Subject: Submittal of Minutes
EAB Meeting No. 13

ATTACHMENT A
MINUTES OF THE 13th ECORISK ADVISORY BOARD MEETING
NETC Newport, Building 1
April 22, 1998

McAllister Point Landfill Revised FS

NEARSHORE MULTI-MEDIA CAP - NO DREDGE

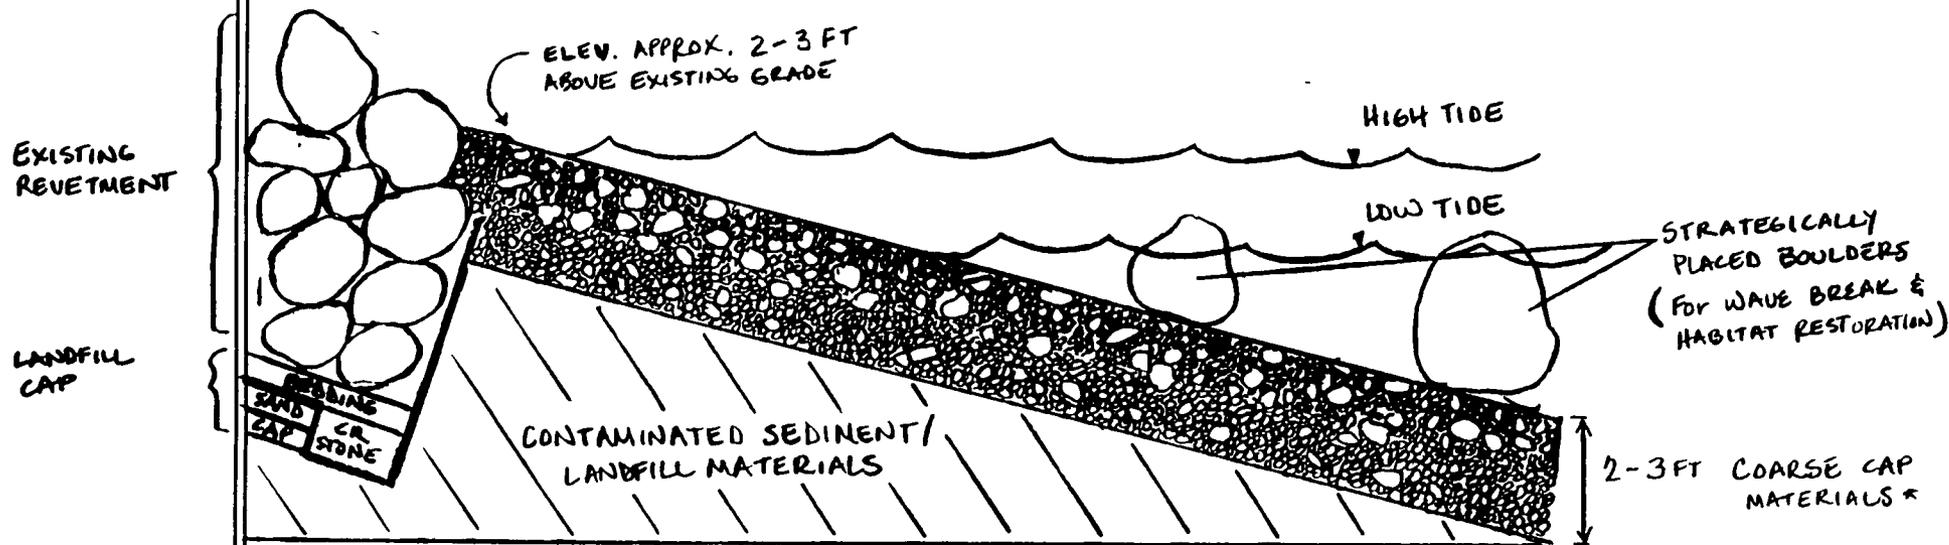
- near-shore multimedia cap placed on top of existing grade (no dredging) using permeable geotextile on both sides of concrete armament system - This would be best suited for high energy areas (between NSB-4/5 and NSB 1). Concrete would protect the upper layer of the geotextile from puncture and assist in its proper placement.

Kymberlee Keckler asked if the objects protruding from the intertidal area would be removed, and Ms. McKenna clarified that the concrete/geotextile would be placed on a subgrade that was prepared to the extent possible.

Jennifer Stump observed that a permeable geotextile is proposed, and asked its purpose. Ms. McKenna pointed out that it is to provide a barrier to sediment migration from the underlying waste materials, as well as an indicator layer to show erosion of natural cover materials prior to disruption of the cap. Ms. McKenna also pointed out that if an impermeable material placed to prevent groundwater movement, only displacement of groundwater to the seaward edge of the cap would be likely.

Jennifer Stump asked if the concrete would be anchored into bedrock. Ms. McKenna stated that it would not, rather its own weight would hold the material in place.

Kymberlee Keckler asked how wide the cap would be. Ms. McKenna explained that the cap is costed to cover all the near-shore area that is shown on the figure (Area A) but actual extent would be determined from the pre-design investigation (PDI).

NEAR-SHORE NATURAL CAP - NO DREDGING

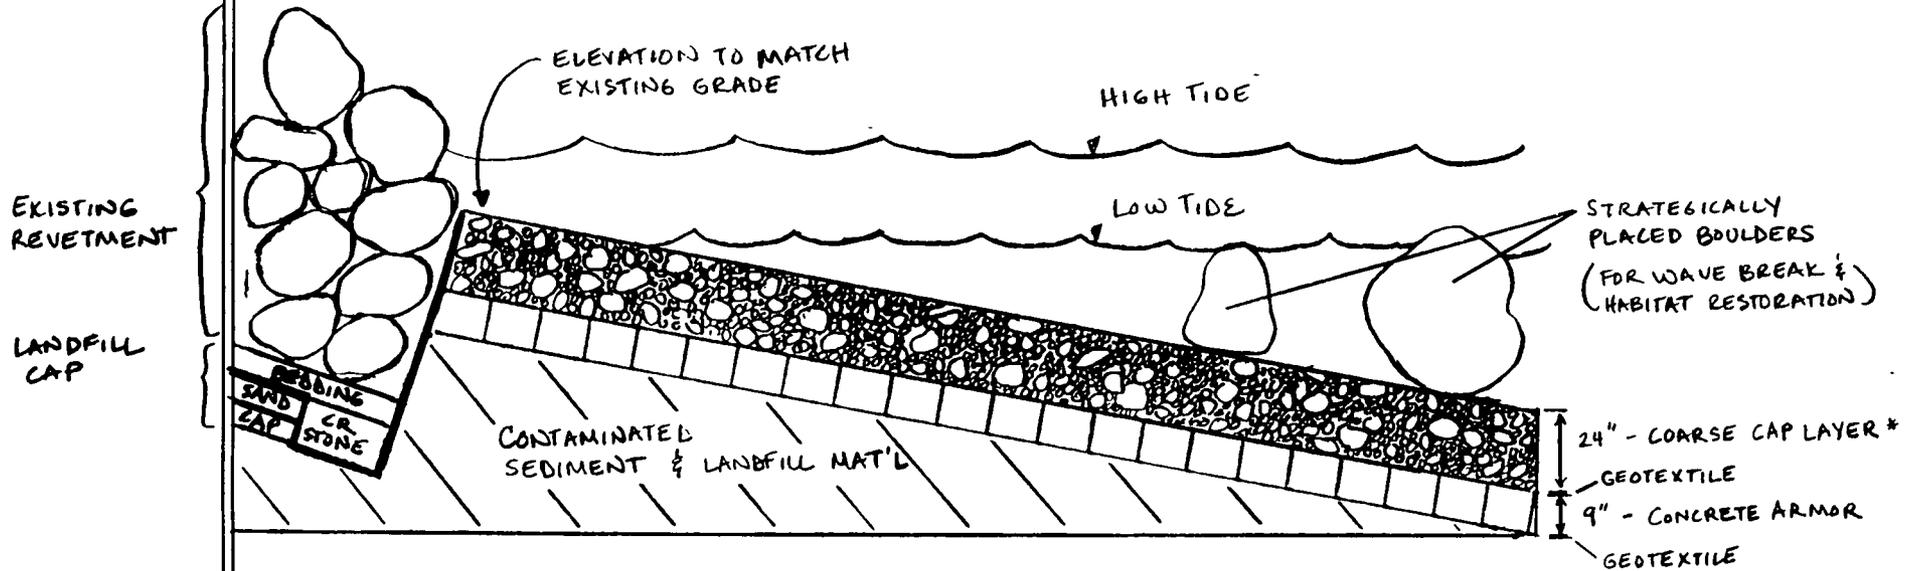
- near-shore natural cap placed on existing grade (no dredging) - This option presents less protection against erosion in high energy areas, since there is no indicator layer, and geotextile is not present to prevent sediment migration to the surface. It is considered as protective for the low energy areas where erosion is less of a concern.

Chris Deacutis asked how the matrix and the slope would change wave action causing additional erosion. Ms. McKenna responded that this option would provide the same slope

and same matrix as is present in the intertidal area to the north of the landfill minimizing change, but this would be considered fully during the design if this option was selected.

NEARSHORE MULTI-MEDIA CAP - W/ DREDGING

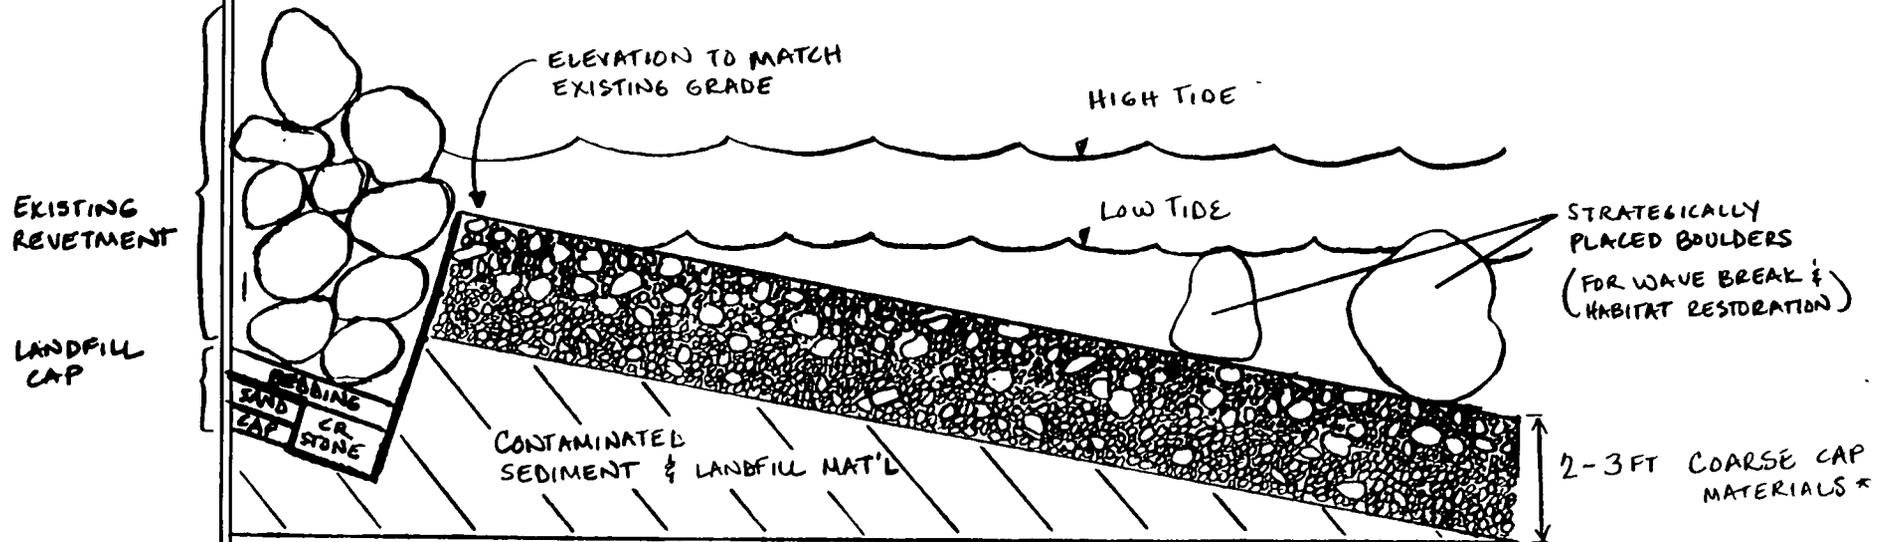
- near-shore multimedia cap placed to match existing grade, requiring approximately 3 feet of material be dredged out - This would be the same option as the first, although with the added cost and difficulty of dredging and disposal.
- near-shore natural cap placed to match existing grade, also requiring approximately 3 feet of material to be dredged out - This also would add to the cost and difficulty via dredge and disposal options.

A question was raised about the cost of this option, and Ms. McKenna explained that the costs had not been worked out completely, but it would come close to the dredging costs for this area.

OFF SHORE NATURAL CAP

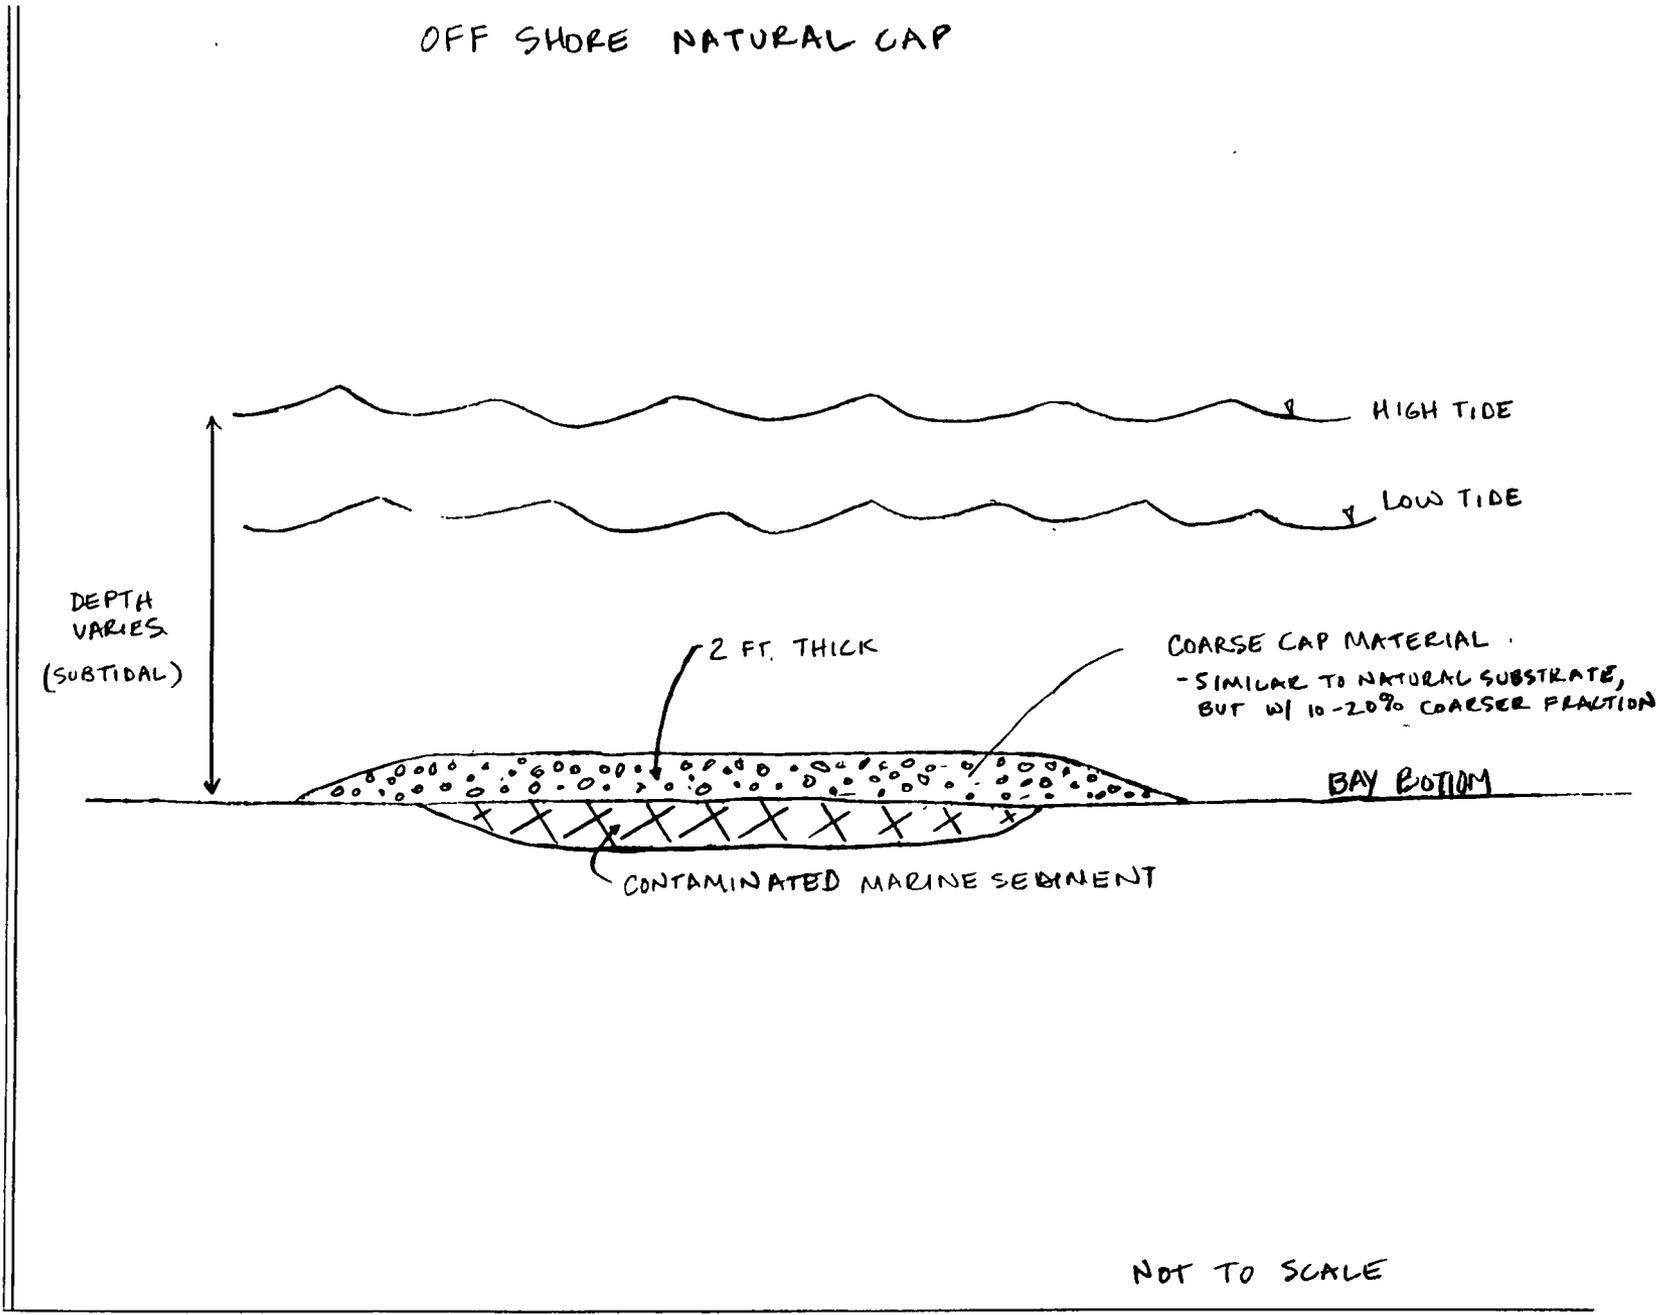
- off shore natural cap, 2 feet of material placed on top of target areas.

Jim Shafer reported that Daniel Averett (U.S. Army Corps of Engineers Waterways Experiment Station) had comments regarding the cost stated in the draft FS, and agreed that it is accurate, based on the existing knowledge. He observed that because of the difficulty level, mechanical dredging should be considered. Cost described in the FS is higher than typical dredging projects because of the location in a shallow marine environment and the matrix.

It was observed that the costs will be different for areas B&C and it was agreed that if practical, the costs would be estimated separately.
